UNITED STATES PATENT AND TRADEMARK OFFICE

APPLICATION NO.	FILING DATE	FIRST NAMED INVENTOR	ATTORNEY DOCKET NO.	CONFIRMATION NO.
10/786,482	02/25/2004	Robert Kronseder	487.1092	3104

Office Action Summary

DETAILED ACTION

REPLACEMENT SHEET

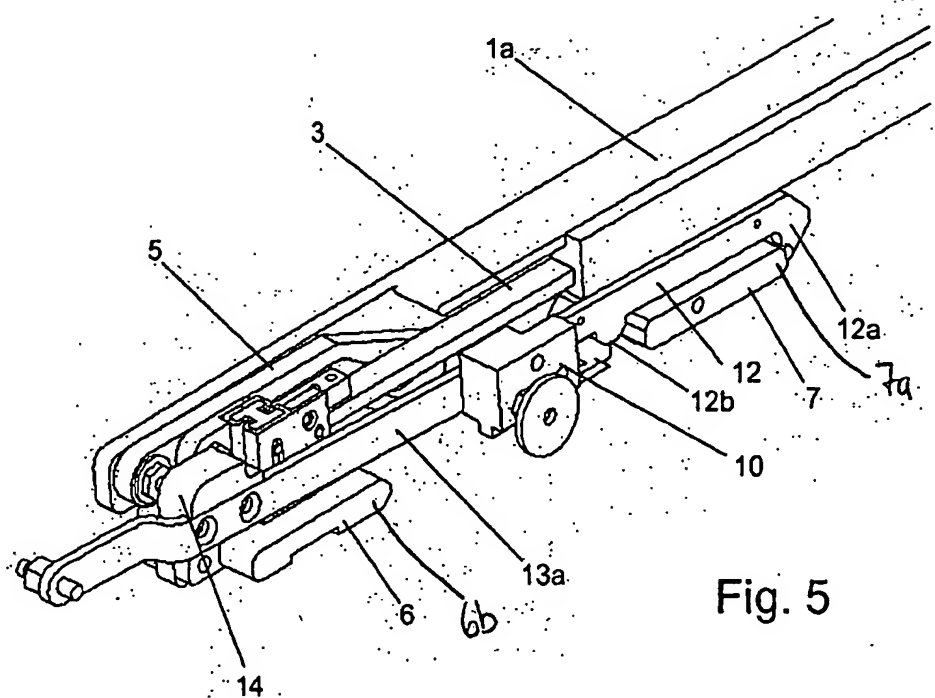
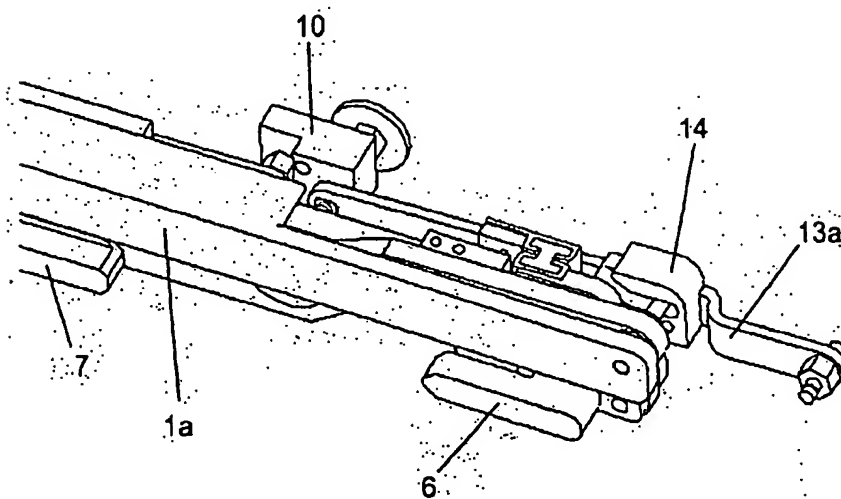
2. The drawings are objected to under 37 CFR 1.83(a) because they fail to show the operative connection of the many components of this invention as described in the specification. Any structural detail that is essential for a proper understanding of the disclosed invention should be shown in the drawing. MPEP § 608.02(d). Corrected drawing sheets in compliance with 37 CFR 1.121(d) are required in reply to the Office action to avoid abandonment of the application. Any amended replacement drawing sheet should include all of the figures appearing on the immediate prior version of the sheet, even if only one figure is being amended. The figure or figure number of an amended drawing should not be labeled as “amended.” If a drawing figure is to be canceled, the appropriate figure must be removed from the replacement sheet, and where necessary, the remaining figures must be renumbered and appropriate changes made to the brief description of the several views of the drawings for consistency. Additional replacement sheets may be necessary to show the renumbering of the remaining figures. The replacement sheet(s) should be labeled “Replacement Sheet” in the page header (as per 37 CFR 1.84(c)) so as not to obstruct any portion of the drawing figures. If the changes are not accepted by the examiner, the applicant will be notified and informed of any required corrective action in the next Office action. The objection to the drawings will not be held in abeyance.

A FURTHER reading of this invention in response to applicant's amendments to clarify the many detailed connections that are set forth currently as a puzzle to be solved has failed to reveal obvious shortcomings of the drawings as well as the disclosure detailed below. For example, it is necessary to show a cross-sectional view of the guide 4 and the engagement therewith in the four claimed positions, the interaction of the cam 12b with the extension (not illustrated) of the first slide 6, necessary to illustrate the numerous articulations disclosed by reference numeral, necessary to show the extension 6b, page 6, of the element 6, necessary to illustrate the interaction of element 3a and 4, the full claimed interaction of the drive block 14 and the control lever 5, necessary to show the coupling element released from ????, page 8, line 34, and the stop of page 9, line 3.

3. The drawings are objected to under 37 CFR 1.83(a). The drawings must show every feature of the invention specified in the claims. Therefore, the first and second coupling element held by means of a catch, claim 1, the rail element proud of the roof, claim 3, the fourth position parallel to a roof, claim 2, the catch lever releasably fixed to the first slide element 6, claim 9, (contrary to applicant's remarks, hook 11 cannot be illustrated as connected to slide shoe 6 in figures 7-8 as no slide shoe is even shown), the entirety of claim 10, and the control lever disengaged from the wind deflector, claim 20 must be shown or the feature(s) canceled from the claim(s). No new matter should be entered.

Corrected drawing sheets in compliance with 37 CFR 1.121(d) are required in reply to the Office action to avoid abandonment of the application. Any amended replacement drawing sheet should include all of the figures appearing on the immediate prior version of the sheet, even if only one figure is being amended. The figure or figure number of an amended drawing
